RE: Approval of Schematic Design and Minor Modifications to Pier 70 Parcel A

MEMO TO THE PLANNING DIRECTOR

Case Number: 2014-001272PHA-03
Project Address: Pier 70 Mixed-Use Project Parcel A
Zoning: P70-MU (Pier 70 Mixed Use)
Pier 70 Special Use District
90-X Height and Bulk District

Recommendation: Approve the Schematic Design and Minor Modifications

C. GROUND FLOOR TRANSPARENCY

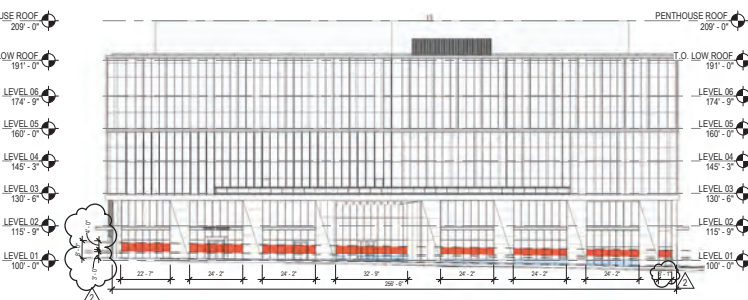
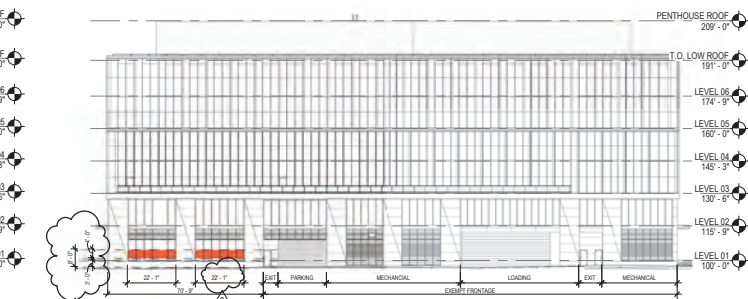
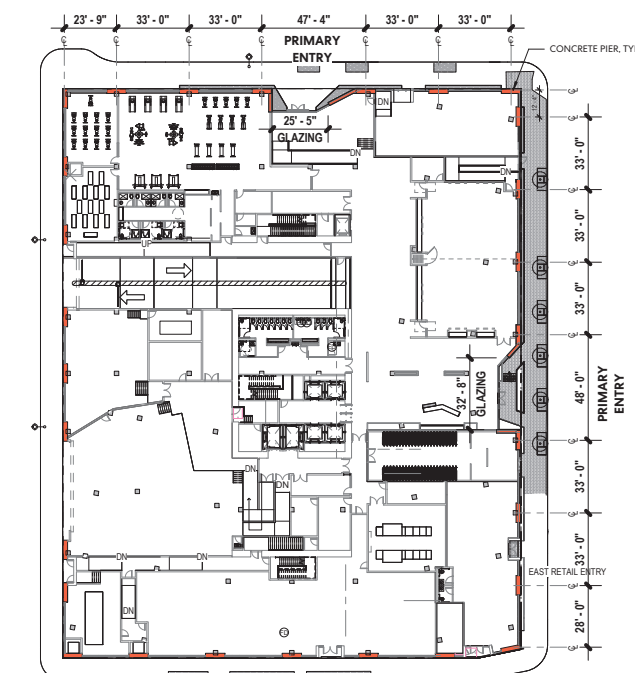
NORTH GF TRANSPARENCY
Total Length = 208' - 2"
Qualifying Transparency Length = 24'-2" + 24'-2" + 25'-5" + 24'-2" + 24'-2" + 17'-10" = 139' - 11"
139'-11" / 208'-2" = 67% (min. required 60% per S6.8.2)

EAST GF TRANSPARENCY
Total Length = 256' - 6"
Qualifying Transparency Length = 22'-7" + 24'-2" + 24'-2" + 32'-9" + 24'-2" + 24'-2" + 6'-1" = 182' - 3"
182'-3" / 256'-6" = 71% (min. required 60% per S6.8.2)

1 65' HEIGHT REFERENCE - NORTH ELEVATION
1" = 40'-0"

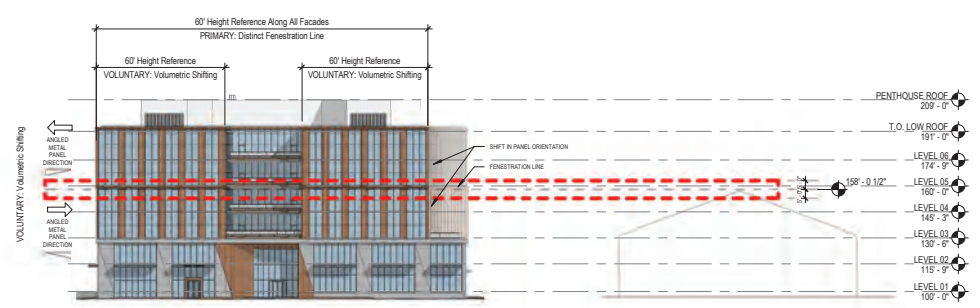
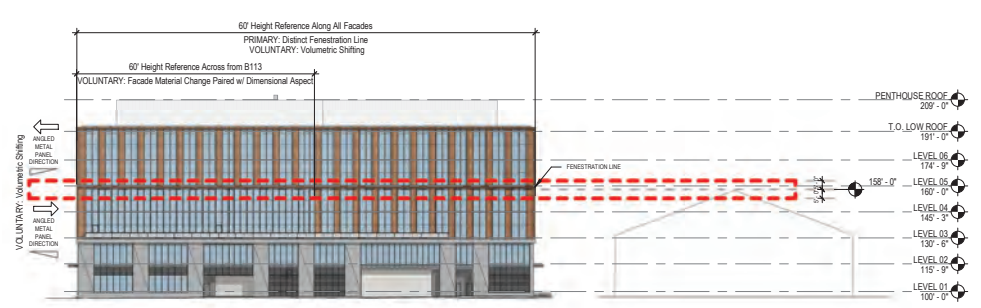
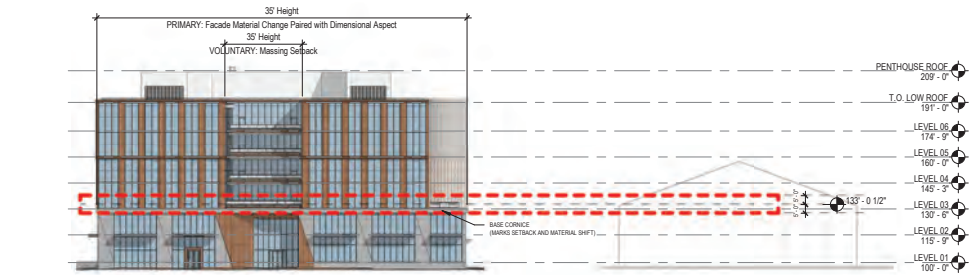
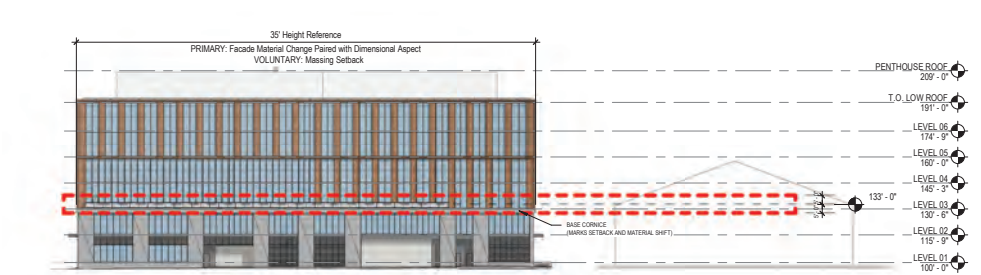
The design team has evaluated this comment and cannot redesign the portion of this building because the added transparency greatly strengthens the dimensional height reference to the adjacent historic structures (required under D4D Standard 6.15) and breaks an otherwise long façade into more than one zone. Additionally, the added transparency benefits the interior space adjacent to the rooftop terraces. After consideration of the design team's analysis, staff concurs with their design assessment and finds the elevation as designed in compliance with the D4D requirements and further design changes would be unwarranted.
